Access Compliance Report

Public Rights-of-Way

(Island Curb Cuts)

Intersection ID: 18488	Main Street: ABBEY_PL	Cross Street: PARK_RD	Location:	W
ADA ID: 52A28028140F	Curb Cut Type: MedianRefuge2	Initial Pass/Fail: Fail	Overall Compliance: No	Severity Score: 22.5
Codes/Mitigation Info/Possible Solution		Field Measurements/Component Compliance

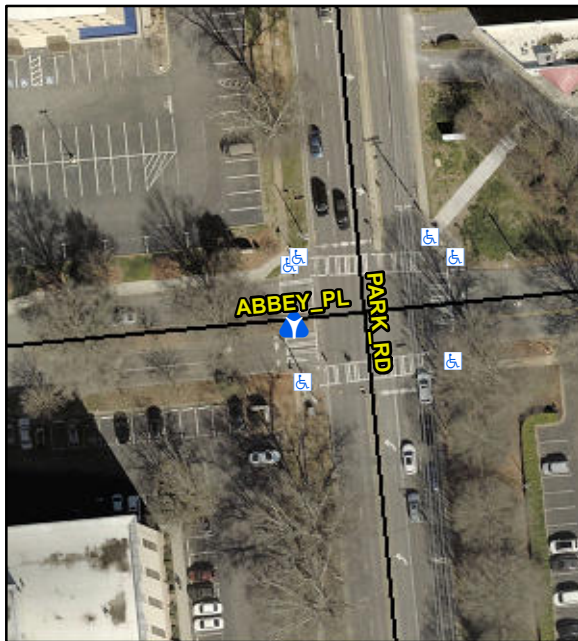
Compliance	Description	Data	Compliance	Description	Data
Yes	Refuge 1 Length (In)	48.5	N/A	Gutter 1 Ponding?	N/A
No	Refuge 1 Width (In)	48.0	N/A	Gutter 1 Lip Ht (In)	N/A
Yes	Refuge 1 Slope (%)	4.7	N/A	Gutter 1 Slope (%)	N/A
No	Refuge 1 X Slope (%)	6.6	N/A	Gutter 1 X Slope (%)	N/A
N/A	Painted X Walk1?	Yes	N/A	DWS 1 Provided?	N/A
N/A	X Walk 1 Direction	To N	N/A	DWS 1 Contrast?	N/A
N/A	X Walk 1 Width (In)	190.0	N/A	DWS 1 Length (In)	N/A
N/A	Road 1 Slope (%)	0.6	N/A	DWS 1 Full Width?	N/A
N/A	Road 1 X Slope (%)	0.2	N/A	DWS 1 Offset (In)	N/A
Yes	Refuge 2 Length (In)	48.5	N/A	Gutter 2 Ponding?	N/A
No	Refuge 2 Width (In)	48.0	N/A	Gutter 2 Lip Ht (In)	N/A
Yes	Refuge 2 Slope (%)	0.3	N/A	Gutter 2 Slope (%)	N/A
Yes	Refuge 2 X Slope (%)	4.4	N/A	Gutter 2 X Slope (%)	N/A
N/A	Painted X Walk2?	Yes	N/A	DWS 2 Provided?	N/A
N/A	X Walk 2 Direction	To S	N/A	DWS 2 Contrast?	N/A
N/A	X Walk 2 Width (In)	192.0	N/A	DWS 2 Length (In)	N/A

Remove & Replace Entire Refuge.
